Addendum 2
Solicitation 24-99847
Shopper's Ramp Demolition and Shoring of New Garrick Building

SECTION 009113 – ADDENDUM NO. 02

Shopper's Ramp Demolition and New Garrick Shoring

SECTION 009113 – ADDENDUM NO. 02
TO BID/PERMIT PACKAGE FOR
LINCOLN PARK COMMUNITY CENTER
Ecolibrium3
Duluth, MN

1 LEVEL 1/FOUNDATION DEMOLITION PLAN

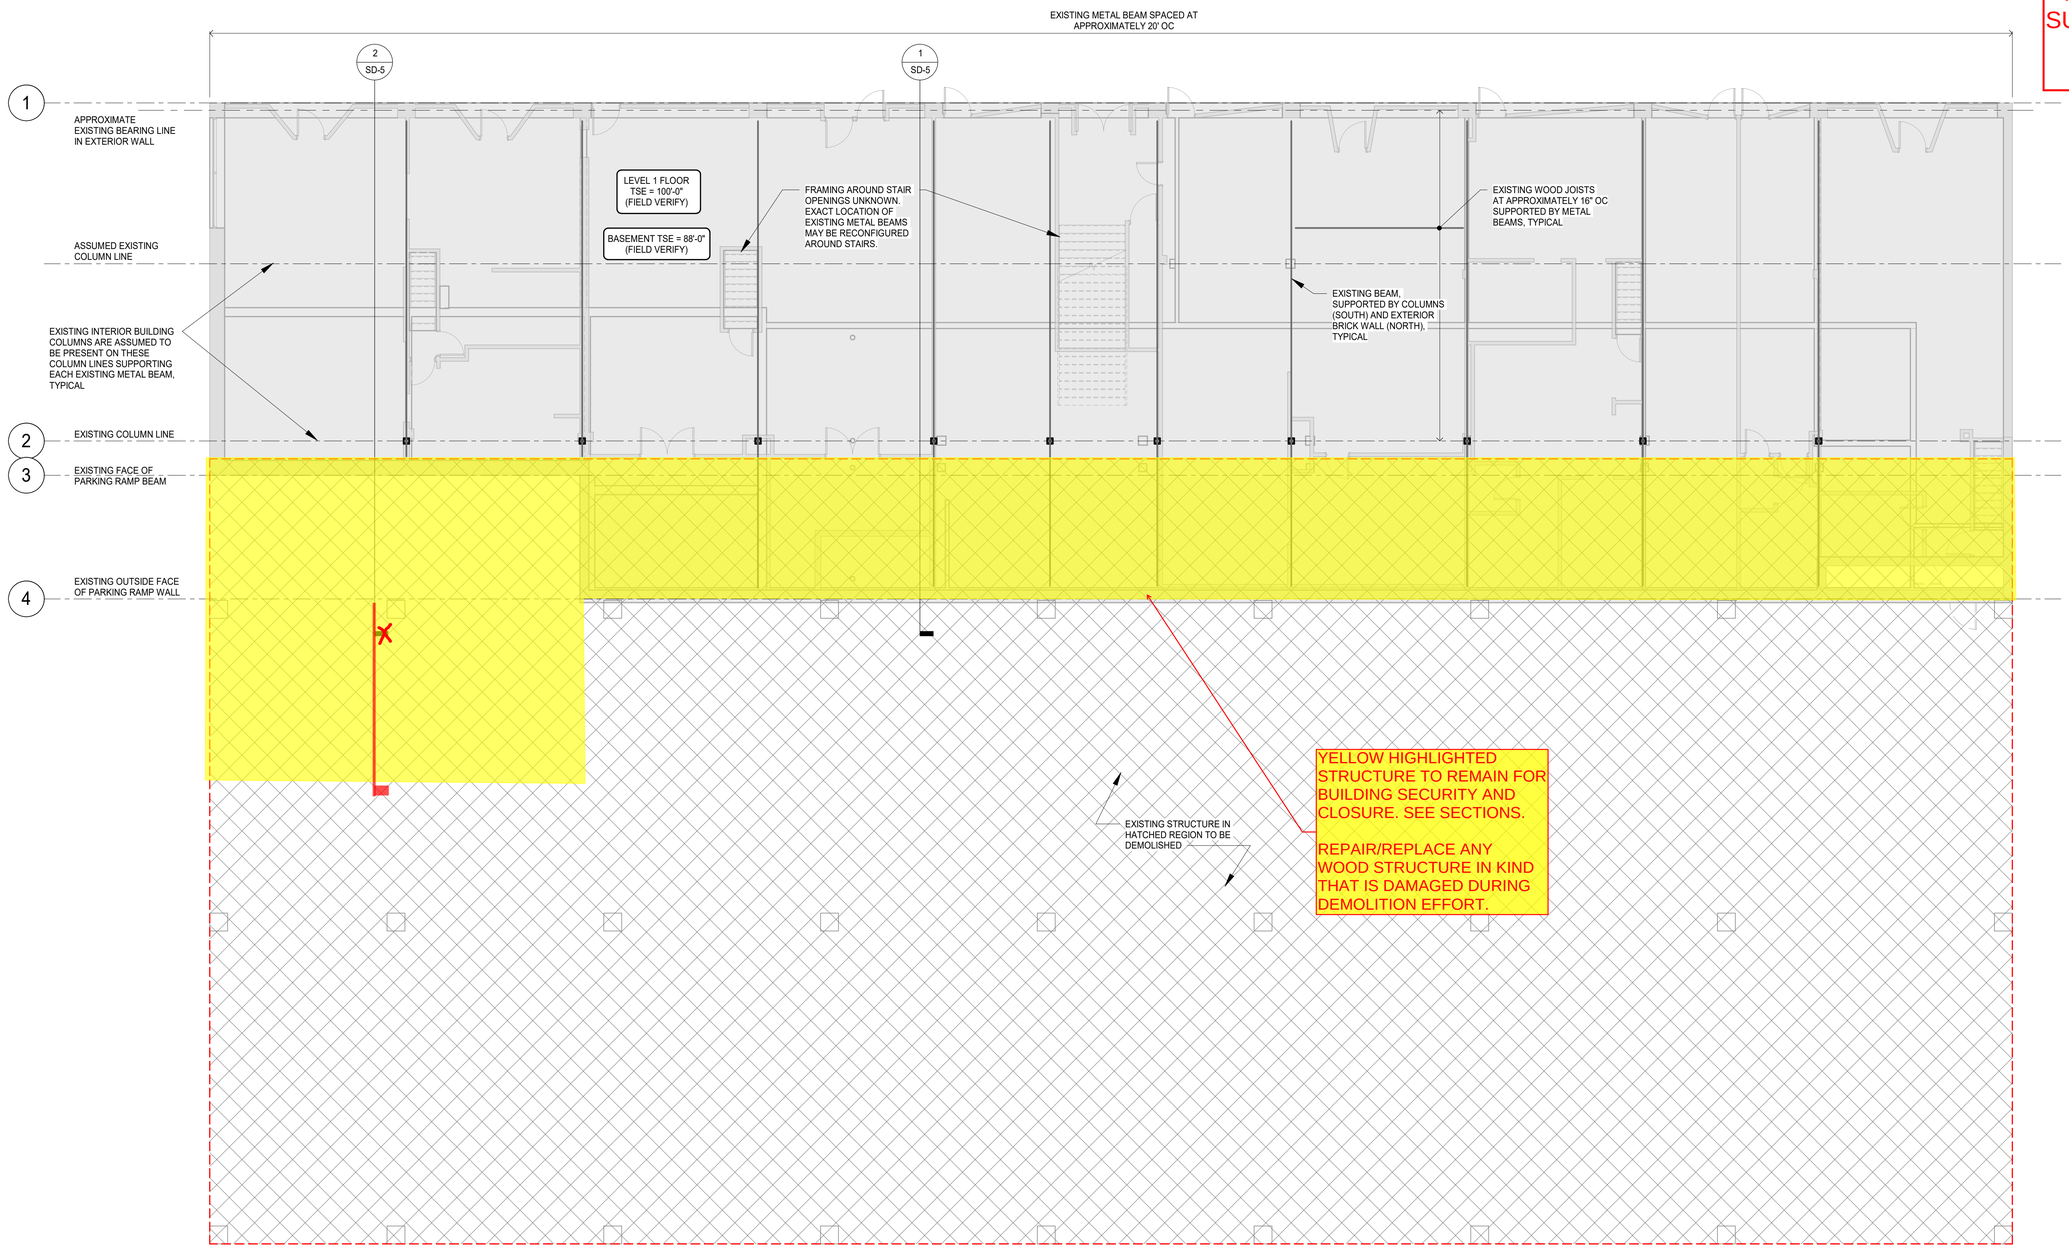
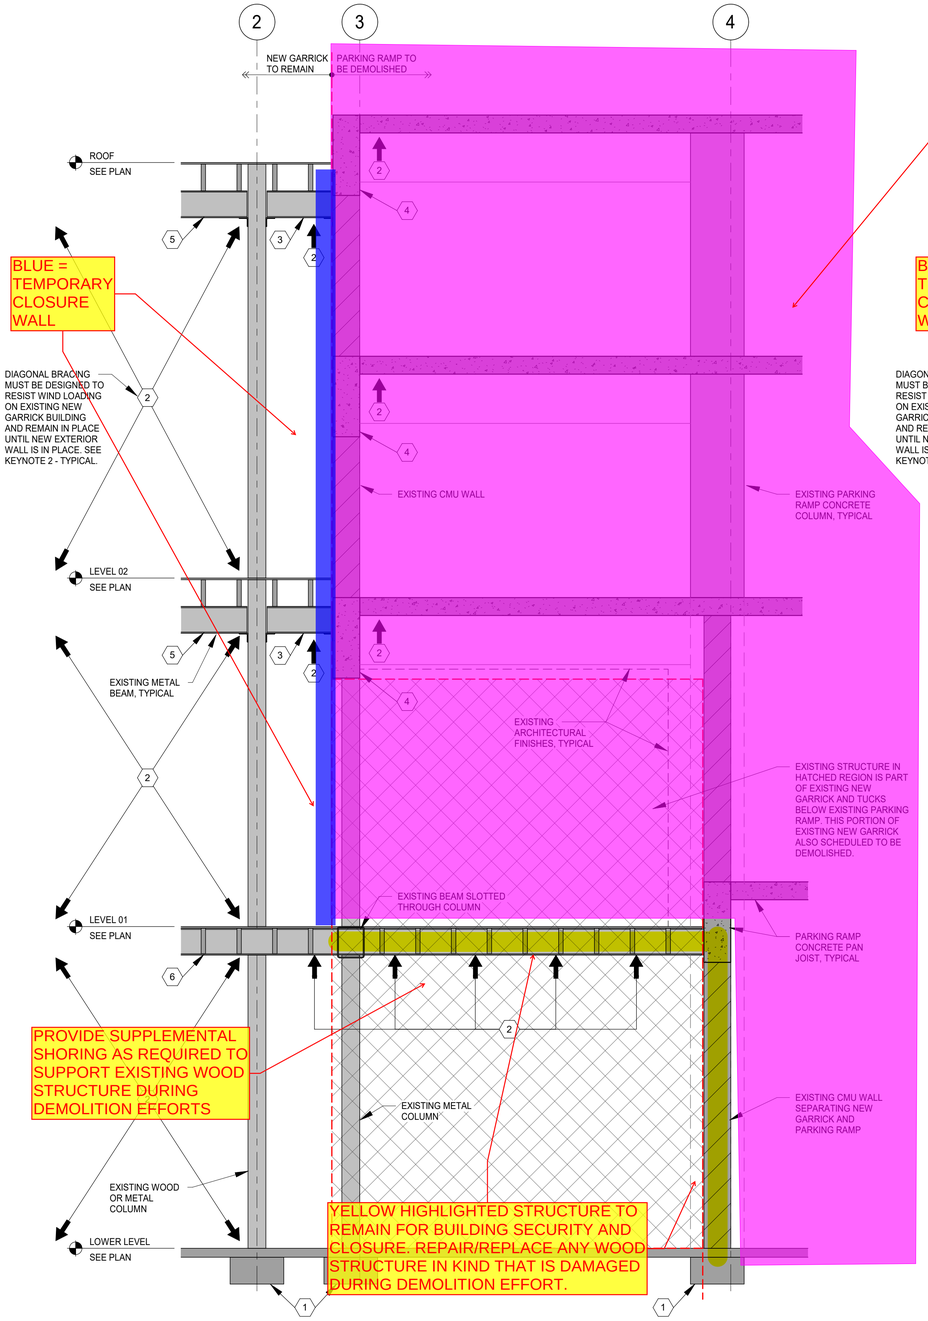
I. **Question:** The building to the north basement could become damaged or might have existing damage, can the parking lot foundation remain along the existing north building.

ADDENDUM 01
SUPPLEMENTAL
INFORMATION
2024-12-06

Answer: Please see attached for supplemental information. Portion of existing wood structure below parking ramp to remain for building security and closure.

1 SD-5 TYPICAL BUILDING SECTION LOOKING EAST

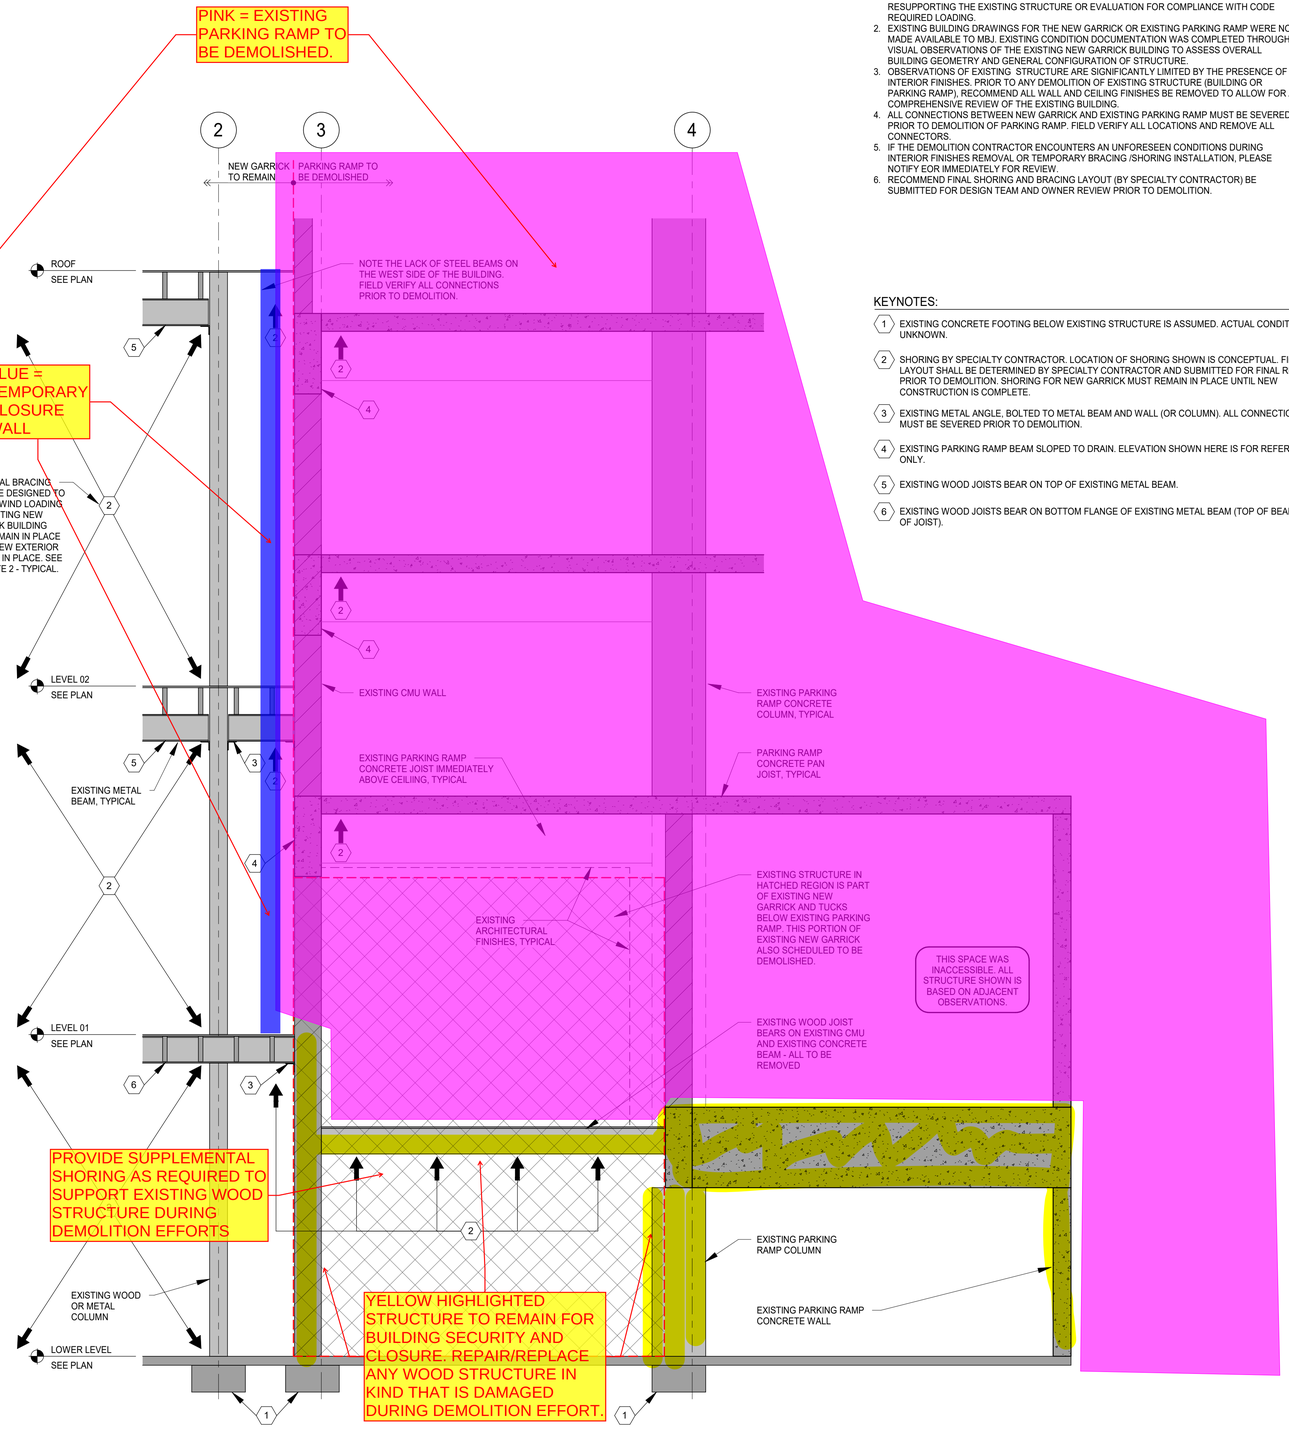
M. **Question:** What will be required for security when the ramp is down to protect the New Garrick Building until phase two?
Answer: 1st St Level & Upper Level minimum of reinforced plastic (10 mil minimum) with 2x6 studs at 24" oc max, floor to floor/roof. Additionally, provide ½" plywood/OSB wall sheathing at 1st St level for security. See question I above for Basement Level. Site fencing to remain until Phase II is complete. Costs for the fencing shall be transferred to the Phase II Contractor or DEDA after the Phase I work is complete.
